# UNITED STATES PATENT AND TRADEMARK OFFICE

APPLICATION NO.	FILING DATE	FIRST NAMED INVENTOR	ATTORNEY DOCKET NO.	CONFIRMATION NO.
09/932,086	08/17/2001	Georg Farkas	CH 000018	5457

### FINAL OFFICE ACTION

FIG. 1

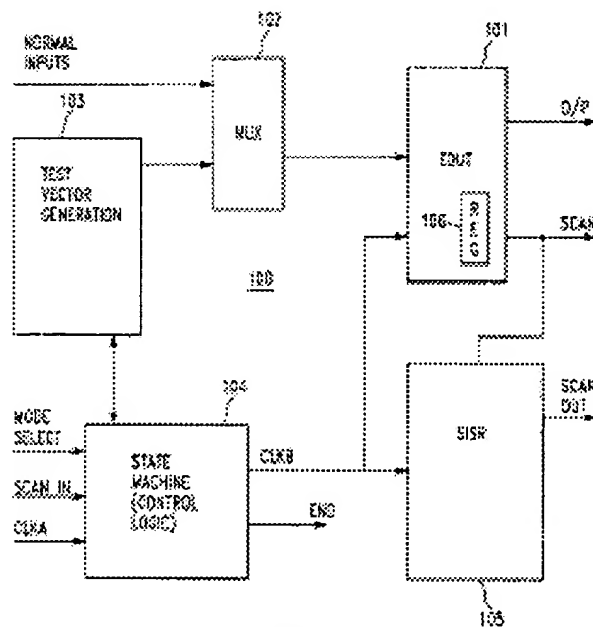
However, Specs does not teaches of exclusively generating test vectors for logic circuitry, but **Barry et al.** discloses a BIST arrangement wherein test vectors are created exclusively for logic circuitry testing in Fig. 1 and col. 8.

FIG. 1

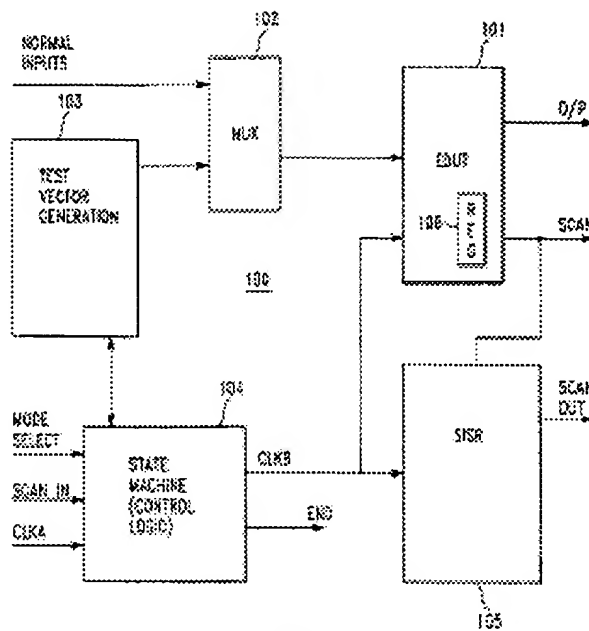
However, Specs does not teaches of compressing test results from the logic circuitry, but **Barry et al.** discloses a BIST arrangement wherein such test result compression means is effected in Fig. 1:block 105 via *sisr*.
